**SUNDRY NOTICES AND REPORTS ON WELLS**  
*Do not use this form for proposals to drill or to re-enter an abandoned well. Use form 3160-3 (APD) for such proposals.*

8. Well Name and No.  
LENGTH CC 6-7 FEDERAL COM 21H

## OXY USA Inc. – Length CC 6-7 Federal Com 21H – SHL Amend APD

### 1. Surface Hole Location Swap

**WELL LOCATION AND ACREAGE DEDICATION PLAT**

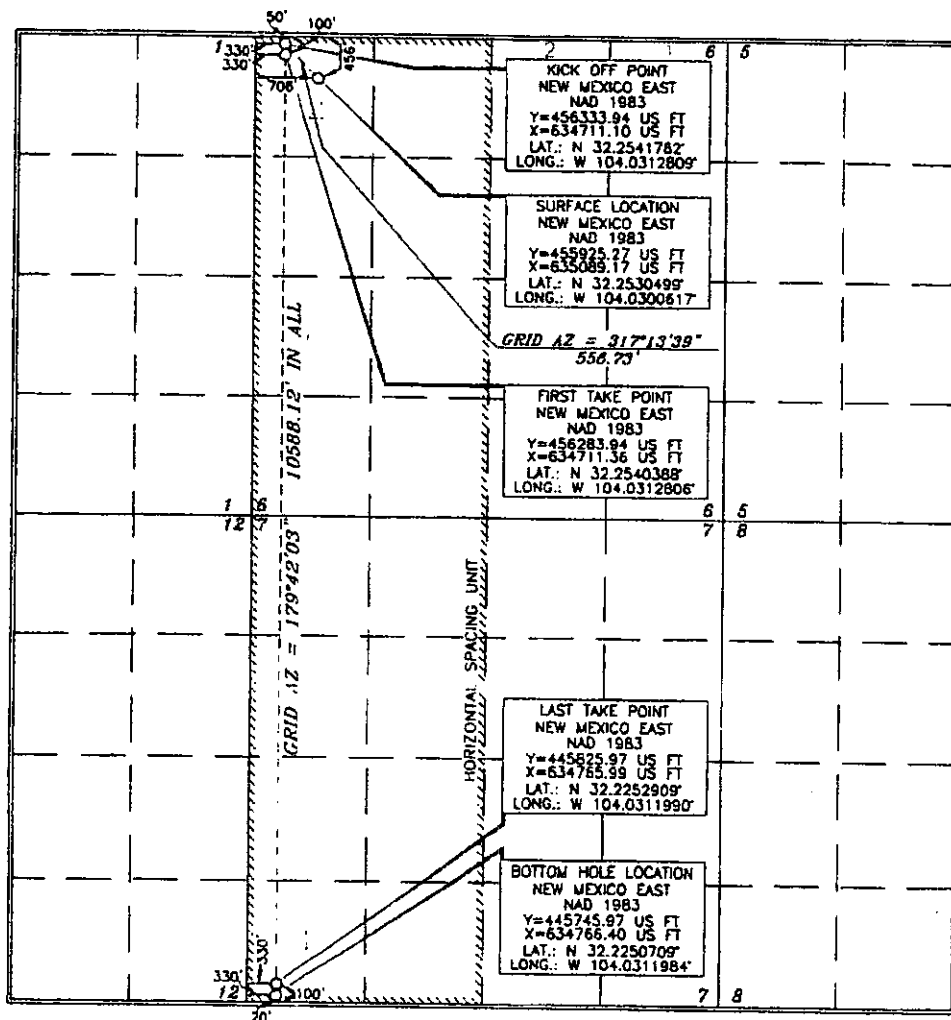
OXY USA Inc. respectfully requests to swap the SHL for the Length CC 6-7 Federal Com 21H ? 30-015-45574 and the Height CC 6-7 Federal Com 31H-30-015-45553. The wells would still drill their originally permitted laterals hitting their approved FTP and LTP.

The change in total well depth is +/- 70?, but overall well construction remains the same other than sundry Notice EC Transaction 453863, Serial Number 950-25738 submitted on 2/8/2019. The surface in this area is private surface and no additional surface disturbance would be incurred by making this swap. The driver to make the request is anti-collision concerns with the current slot arrangement. We acknowledge we should have caught the AC issues prior to filing the original sundry, but greatly appreciate the BLM's support in resolving the issue.

UL or lot no.	Section	Township	Range	Lot Idn	Feet from the	North/South line	Feet from the	East/West line	County
4	6	24 SOUTH	29 EAST, N.M.P.M.		456'	NORTH	706'	WEST	EDDY

UL or lot no.	Section	Township	Range	Lot Idn	Feet from the	North/South line	Feet from the	East/West line	County
4	7	24 SOUTH	29 EAST, N.M.P.M.		20'	SOUTH	330'	WEST	EDDY

LENGTH CC "6\_7" FEDERAL COM #21H  
LOCATED AT 456' FNL & 706' FWL IN  
SECTION 6, TOWNSHIP 24 SOUTH, RANGE 29  
EAST, N.M.P.M., EDDY COUNTY, NEW MEXICO

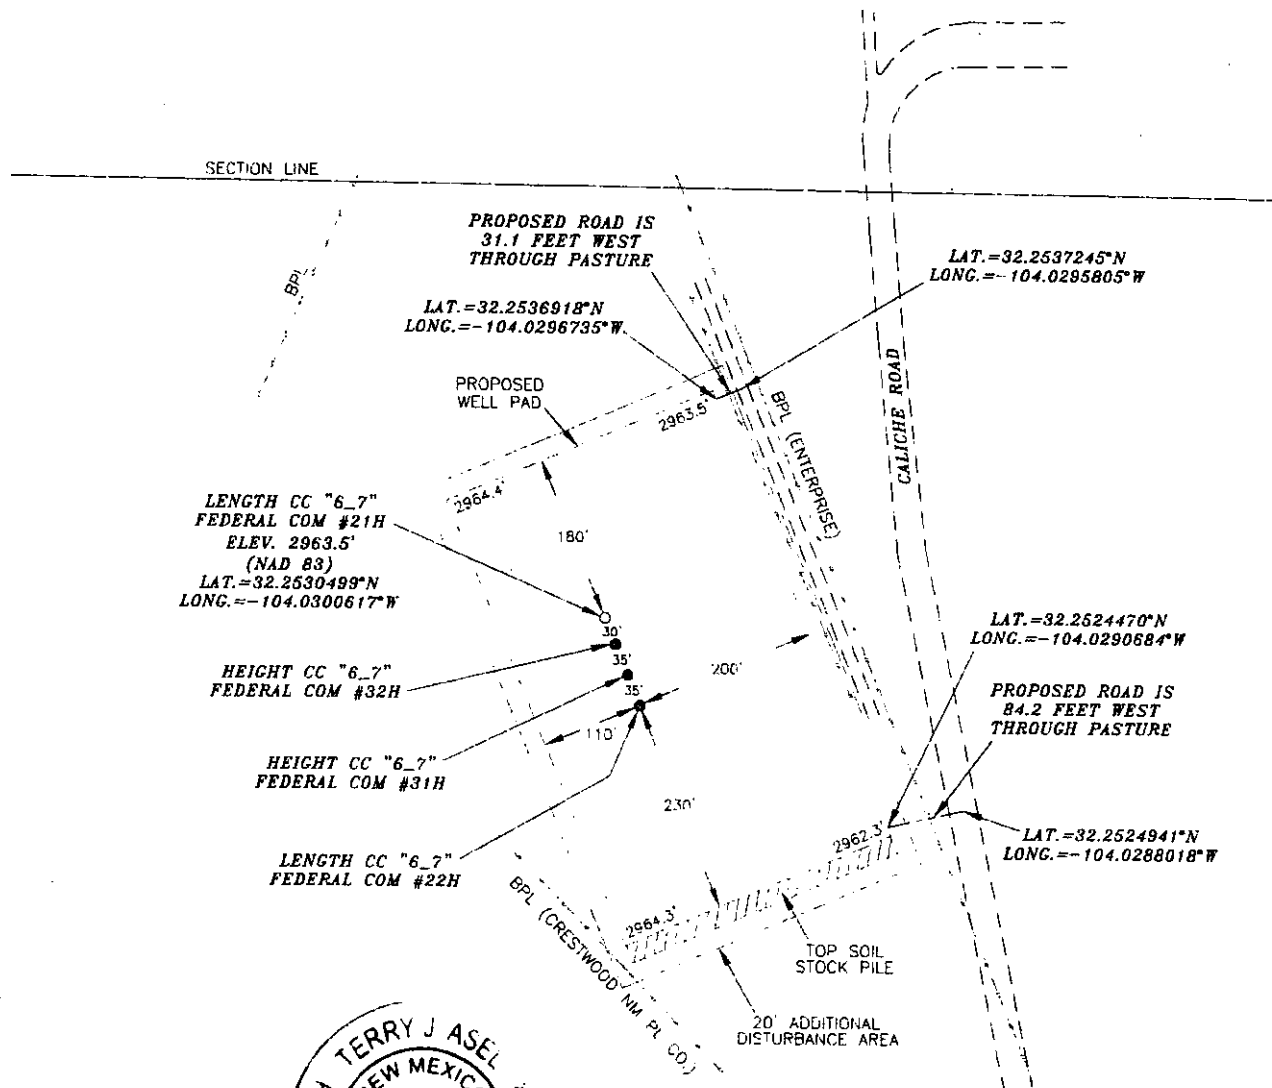
OXY USA Inc. respectfully requests to swap the SHL for the Length CC 6-7 Federal Com 21H – 30-015-45574 and the Height CC 6-7 Federal Com 31H-30-015-45553. The wells would still drill their originally permitted laterals hitting their approved FTP and LTP. The change in total well depth is +/- 70', but overall well construction remains the same other than sundry Notice EC Transaction 453863, Serial Number 950-25738 submitted on 2/8/2019. The surface in this area is private surface and no additional surface disturbance would be incurred by making this swap. The driver to make the request is anti-collision concerns with the current slot arrangement. We acknowledge we should have caught the AC issues prior to filing the original sundry, but greatly appreciate the BLM's support in resolving the issue.
